Terminal connection changes:  
 KPW171 with single part connectors to new style KPW171C with two part connectors.

**MTD KPW171 T-A**

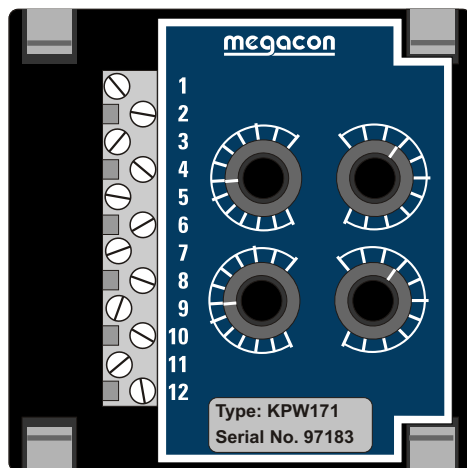
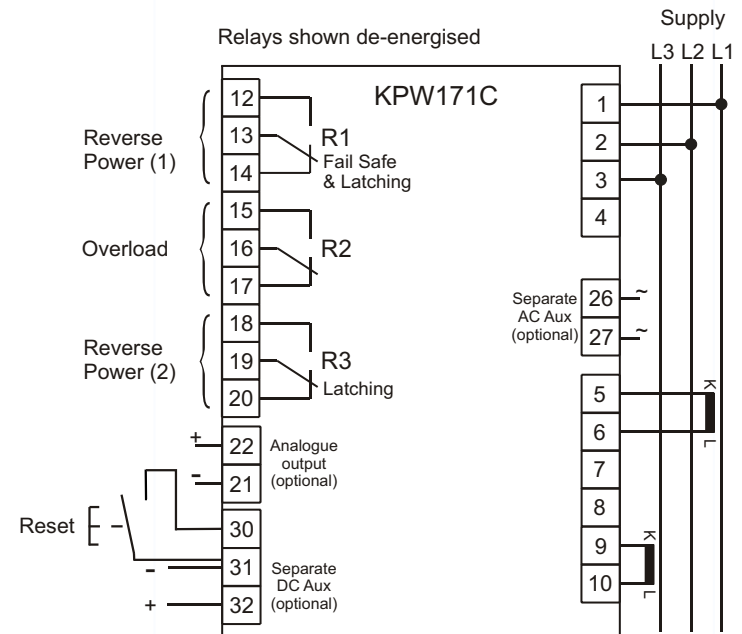
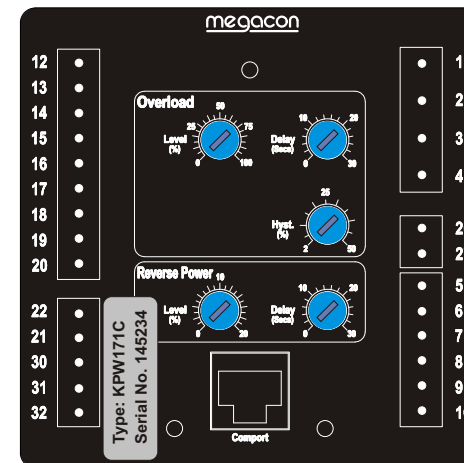
KPW171 Terminal	KPW171C Terminal
1	1
2	2
3	3
4	12
5	13
6	15
7	16
8	17
9	5
10	6
11	9
12	10
